UNITED STATES ENVIRONMENTAL PROTECTION AGENCY
REGION 6
1445 ROSS AVENUE, SUITE 1200
DALLAS, TEXAS 75202-2733

MEMORANDUM

SUBJECT: Impromptu visual cap inspection at the San Jacinto River Waste Pits superfund site

Figure 1- Areas to be covered with additional rock and flatten slopes from November 2013 Armor Cap Enhancement plan

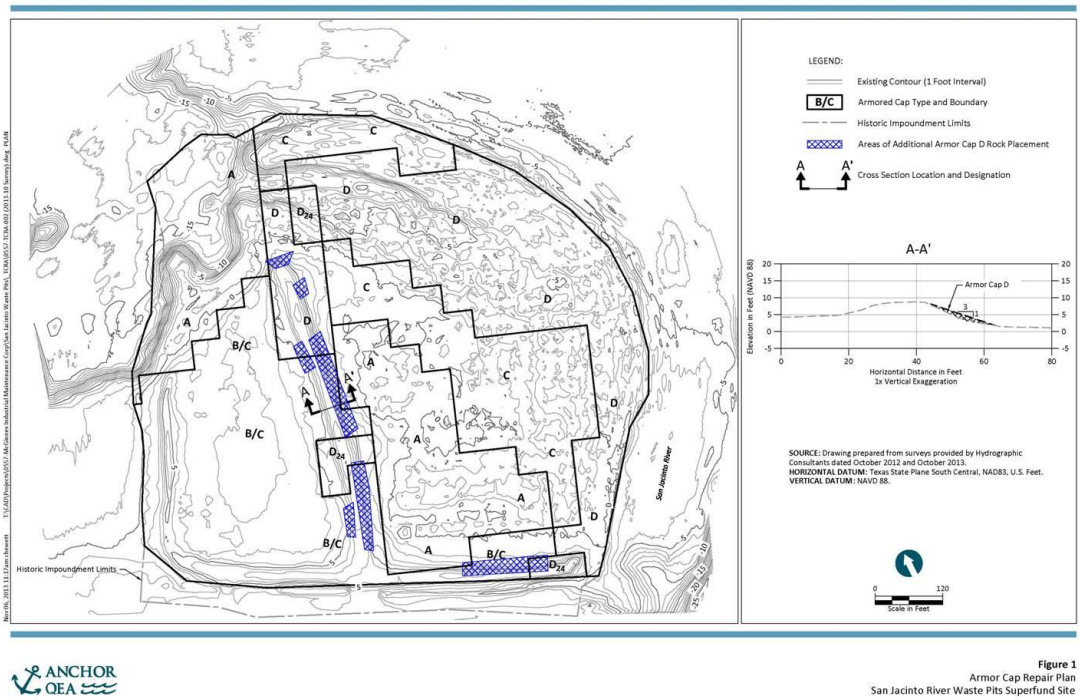
In addition to inspecting the overall integrity of the armor cap, seven additional areas (see Figure 1) were inspected where additional rock was placed and the slopes flattened to provide more stability and strength per the enhancement work plan dated November 2013. The section of the armor cap located above water level (western cell) was observed to be intact with no areas of cap erosion evident (see Photo 1-2). It was noted that several small areas of minor cap erosion along the central berm were evident by patches of the geotextile filter fabric exposed (See Photos 3-5).
